# **Airport East precinct – WestConnex enabling works**

August 2015

Submissions Report

**Figure 4-1** Refined proposal area boundary

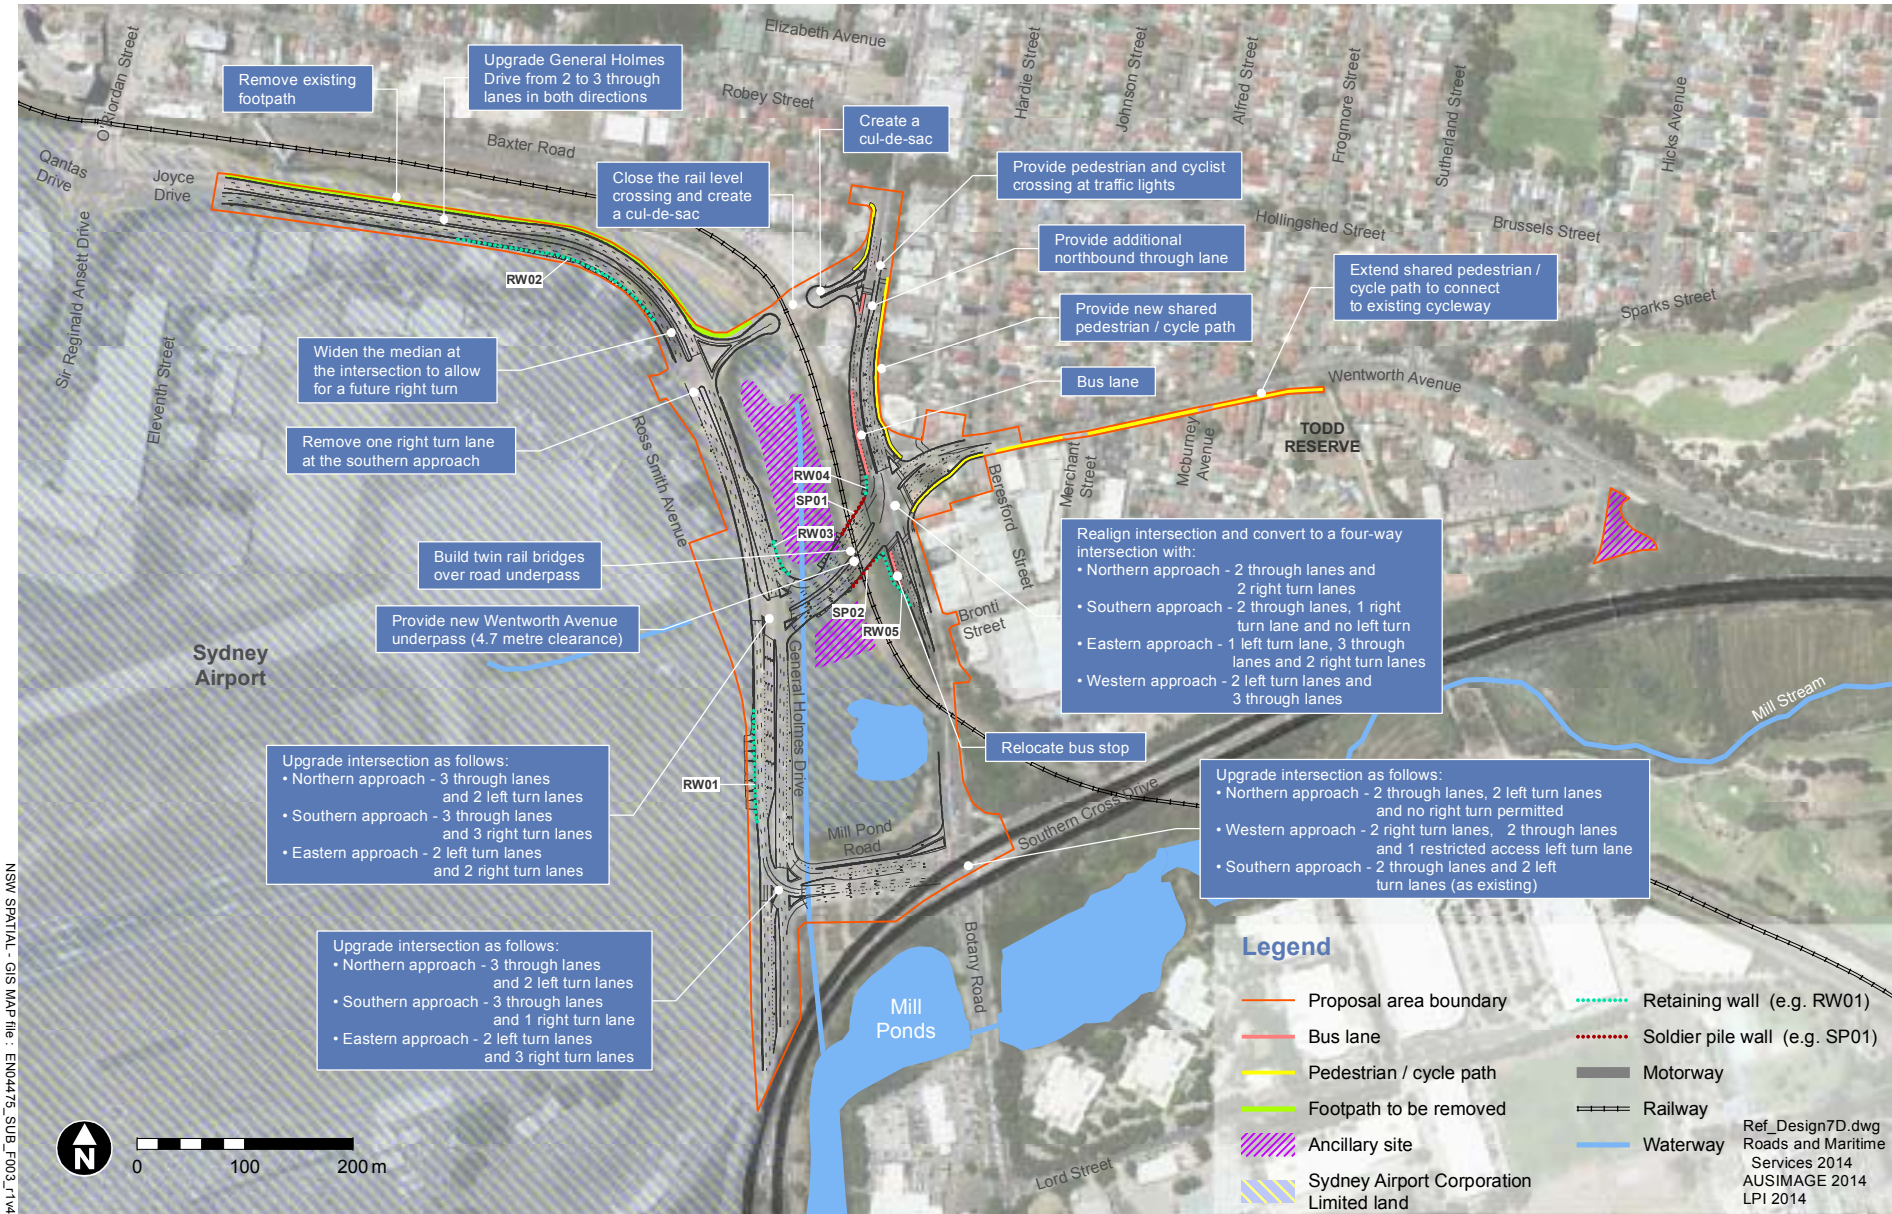
Following the display of the REF, Roads and Maritime adjusted the proposal area to include about 400 metres of shared-use path along the south of Wentworth Avenue. The refined proposal area boundary is shown in **Figure 4-1**.
